MILPITAS PLANNING COMMISSION AGENDA REPORT

TITLE: BART Extension to Milpitas, San Jose and Santa Clara DEIS/DEIR

Proposal: Review City's comment letter on the DEIS/DEIR

Re: Draft Environmental Impact Statement/Environmental Impact Report
BART Extension to Milpitas, San Jose, and Santa Clara, CA

CITY OF MILPITAS - MONTAGUE/CAPITOL STATION

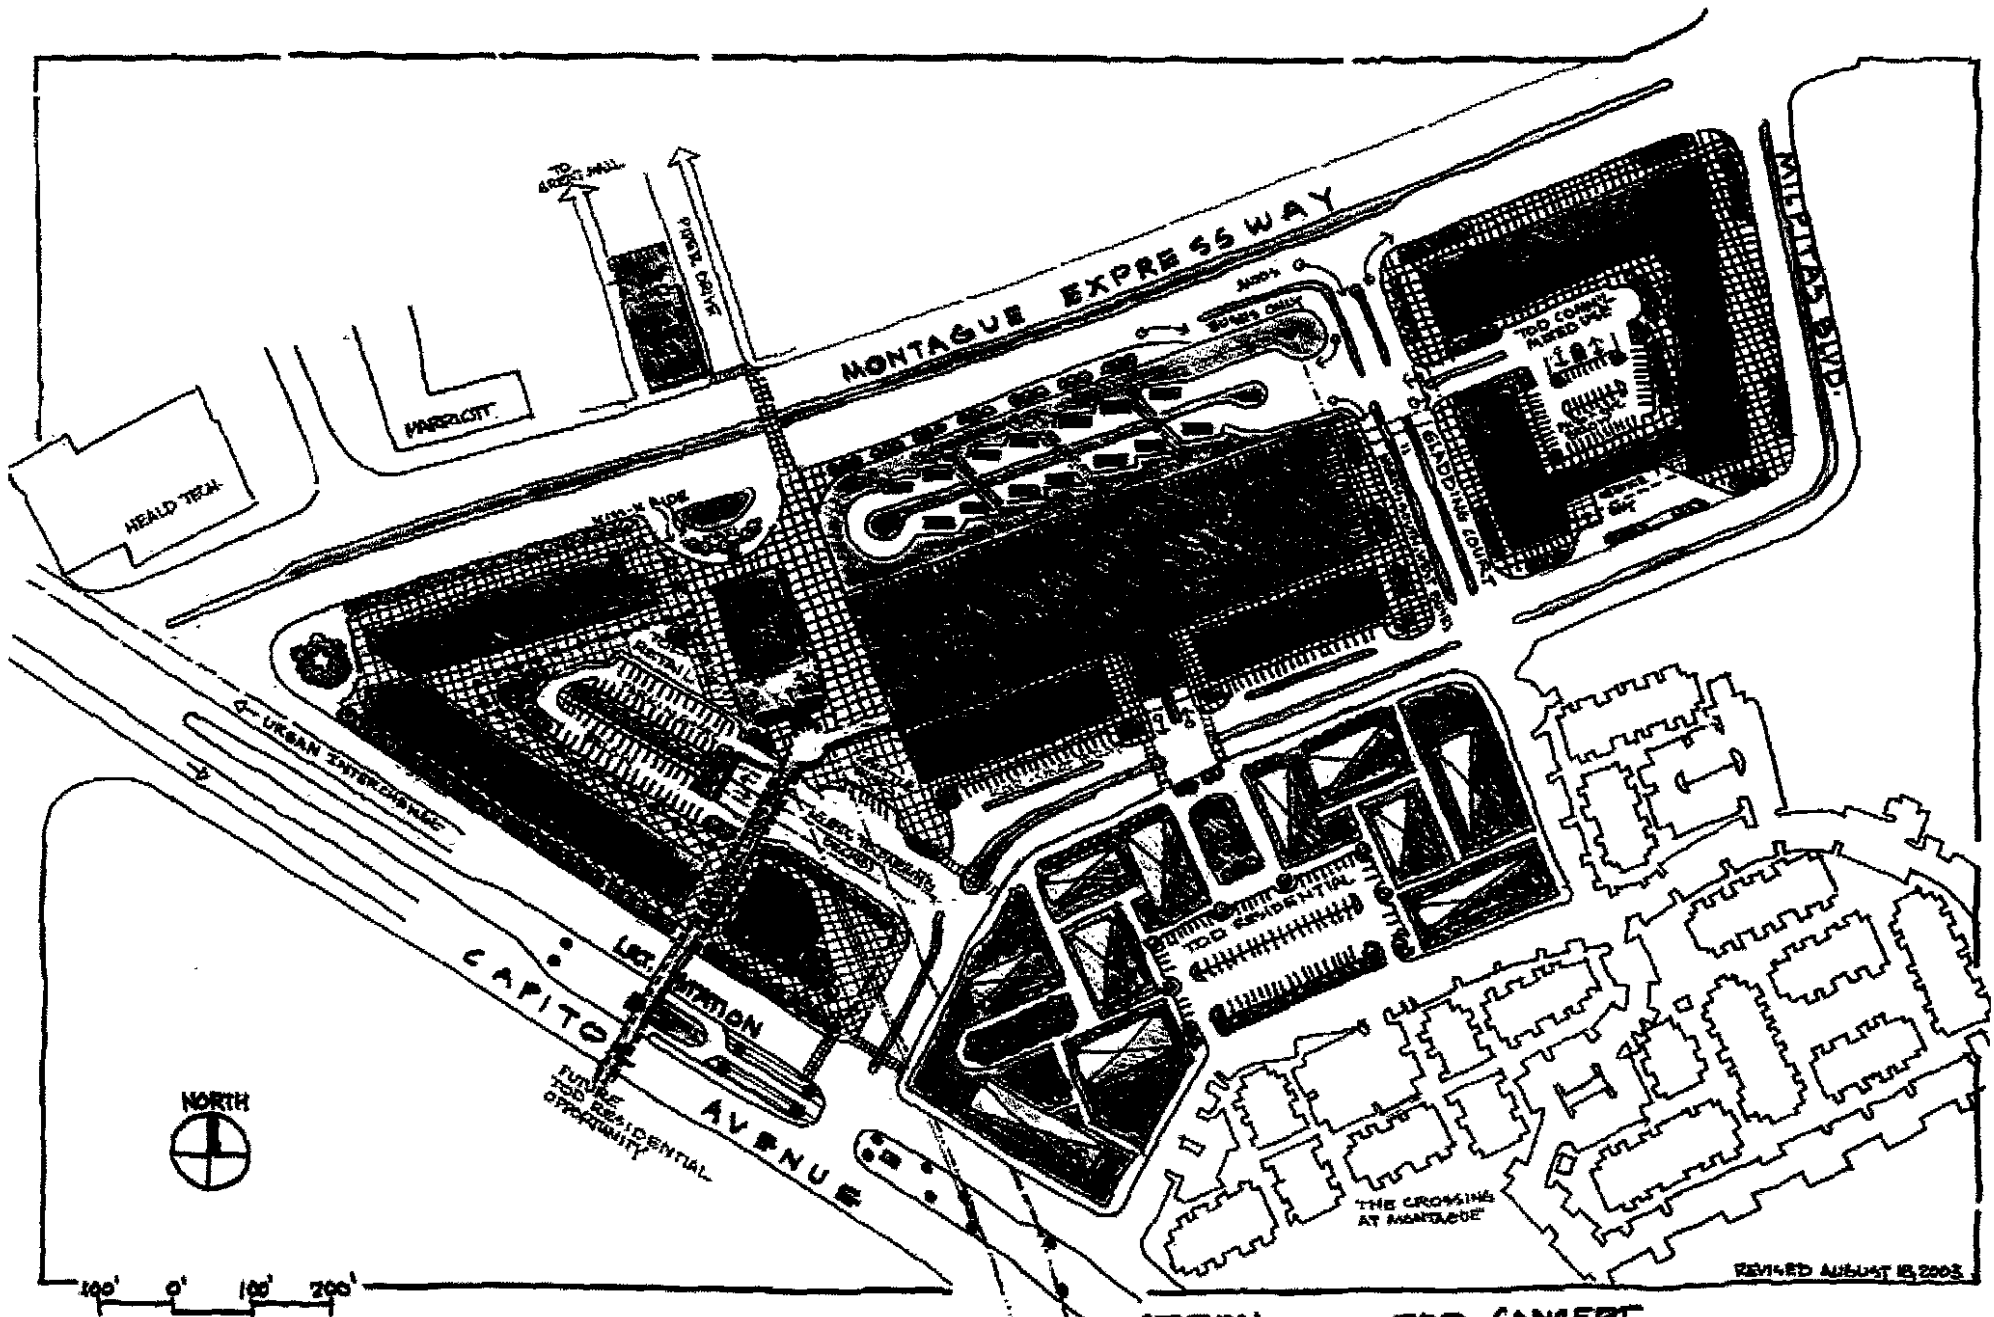
Milpitas developed an alternative design for the Montague/Capitol station as depicted in **Attachment B**. The plan will be further refined through a Transit Area Plan process that the City will initiate in the summer. The plan:

- a. Provides a parking structure adjacent to Montague and extending east to Gladding Court. This would minimize property acquisition south of the Milpitas Boulevard extension and east of Gladding court (other than the Milpitas Boulevard extension) and encourage the redevelopment of those properties;
- b. Provides a compact footprint that would encourage pedestrian and bicycle travel;
- c. Provides a more urban transit experience with a plaza and transit-related retail;
- d. Provides aerial walkways to the light rail station and adjacent land uses to the southwest;
- e. Optimizes connection to the Great Mall with walkway under Montague and a station entry north of Montague; and
- f. Provides a bus transit center under the parking structure adjacent to Montague.

The DEIS/EIR should consider the alternative Montague station design plan so the TOD potential of the area surrounding the station can be maximized.
